LiDAR Quality Assessment Report

WI_Taylor_2017

The Taylor County lidar project is a portion of the Wisconsin WROC / 3DEP LiDAR 2016-17 acquisition task order, issued by Ayres under their Task Order 20 dated March 7, 2016. Project area covers approximately 992 square miles which includes a 100 meter buffer around the county boundary. The lidar data was acquired at a nominal point spacing (NPS) of 0.7 meters and a single swath nominal point density (NPD) of 2.0. Project specifications are based on Washburn County requirements and on the U.S. Geological Survey National Geospatial Program LiDAR Base Specification, Version 1.2. The data was developed based on a horizontal projection/datum of NAD83 (2011) / WISCRS Taylor (ftUS) (EPSG Code: 7640), and vertical datum of NAVD88 - Geoid12A (Feet).

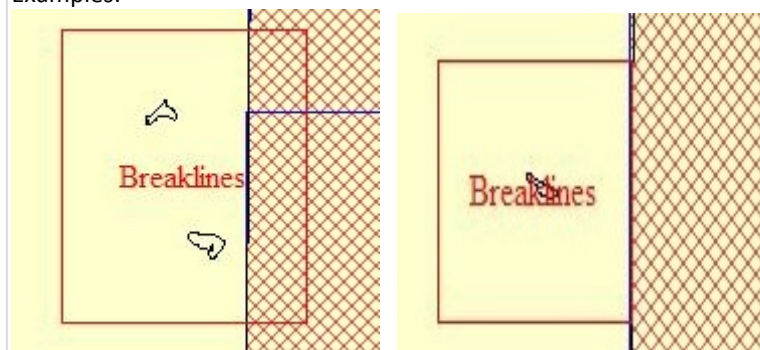
- There are 14 breaklines outside the AOI. See Errors shapefile.

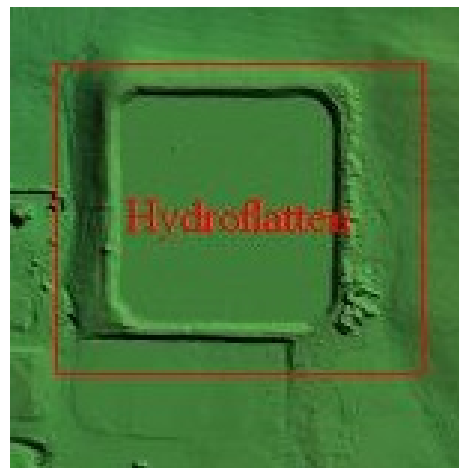
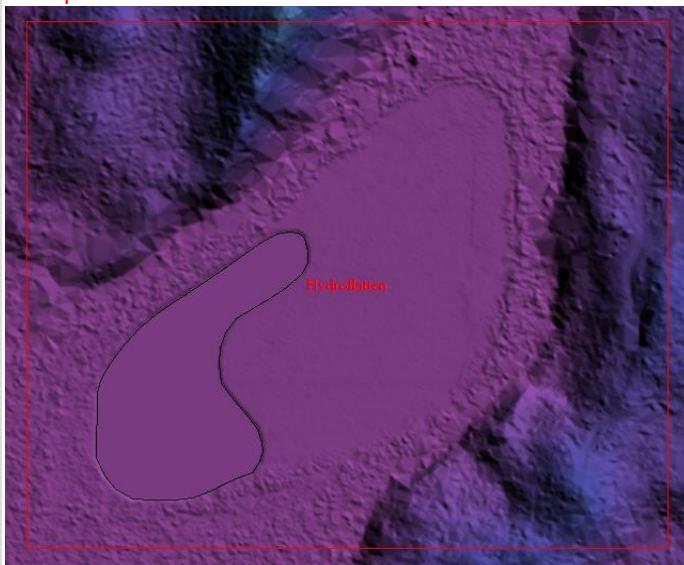
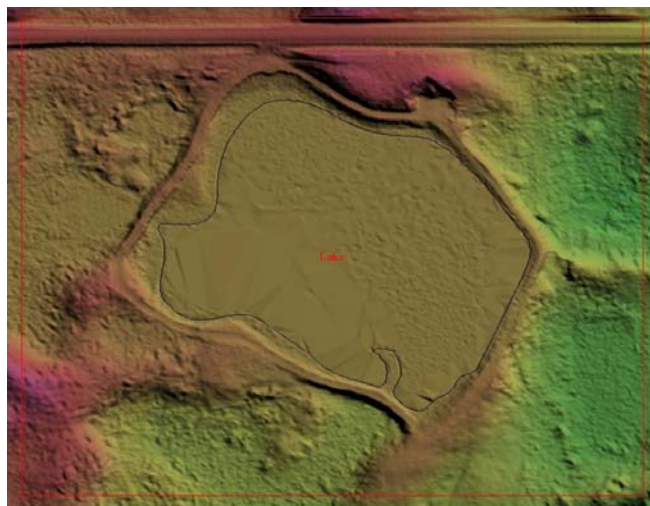
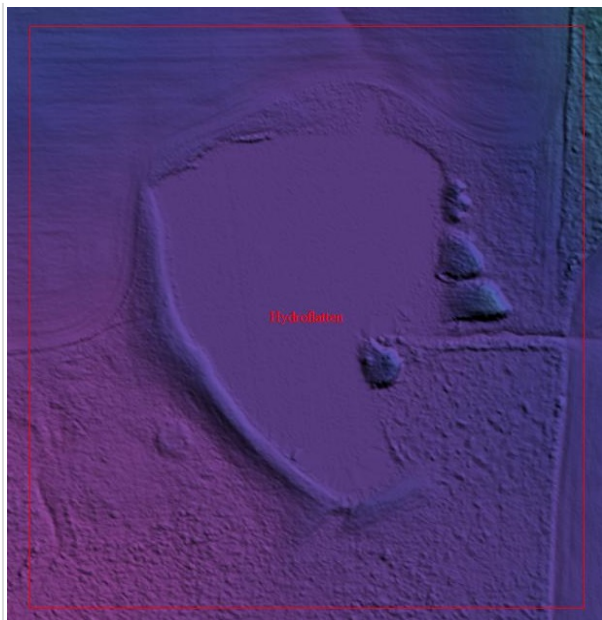
- 20 Waterbodies need to be hydroflattened, hydroflattened correctly or hydroflattened correctly. See Error shapefile.
Examples:
